McCULLOCH

SERVICE BULLETIN # 1077A

MODEL 1-70, 1-80, MC-10 DATE 8/5/60

SUBJECT NEW CRANKCASE CYLINDER ASSEMBLY AND CRANKSHAFT

P/N 55517

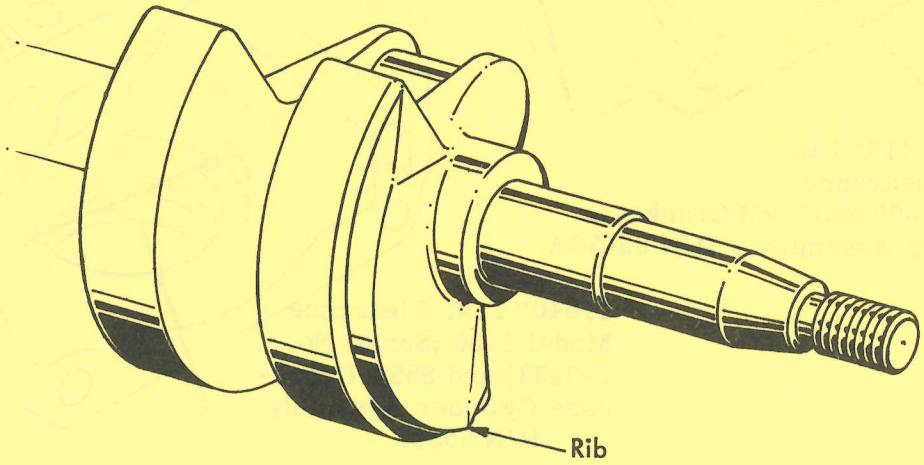
A new, better balanced Crankshaft, P/N 55517, which has been designed to reduce engine vibration, replaces crankshaft, P/N 55257, on Model 1-70, 1-80, and MC-10 engines. Improved balance is provided by a circular-shaped rib on the crankshaft counterweight (see illustration).

2.418" Dia. Clearance
Model 1-70 and 1-80 Crankcase Cylinder Assembly - P/N 55438A

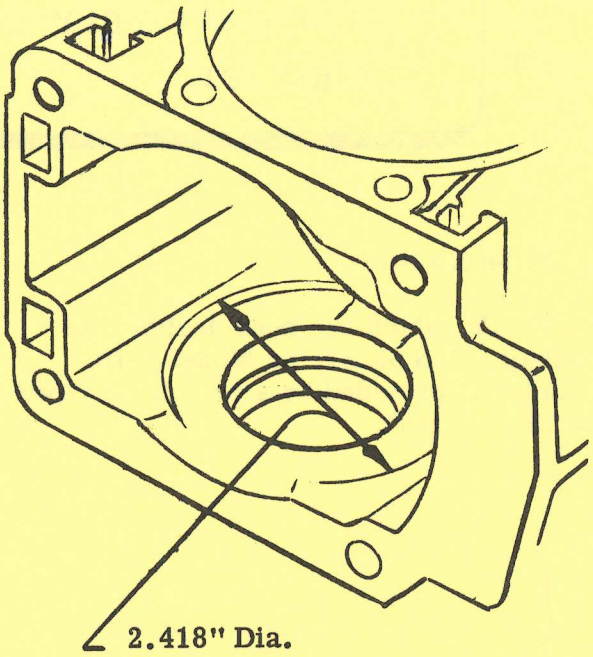
Changes in the crankshaft made necessary a casting change in the crankcase cylinder. The new Crankcase Cylinder Assembly, P/N 55438A, replaces P/N 55438 and P/N 55301 and can be used on earlier Model 1-70, 1-80, S55A, and S44A engines when replacement is necessary.

When the 55438 and 55301 crankcase cylinder assemblies are replaced with the new 55438A Crankcase Cylinder Assembly, either the new Crankshaft, P/N 55517 or the old crankshaft, P/N 55257 can be used as shown in Table 1. However, the new Crankshaft, P/N 55517, cannot be used on the earlier engines which contain the 55438 and 55301 crankcase cylinder assemblies. The interference between the 55517 Crankshaft counterweight area and the old crankcase cylinder walls will cause the crankshaft to bind in the crankcase cylinder.

The difference between the 55438A and 55301 crankcase cylinder assemblies is shown in the following illustration.
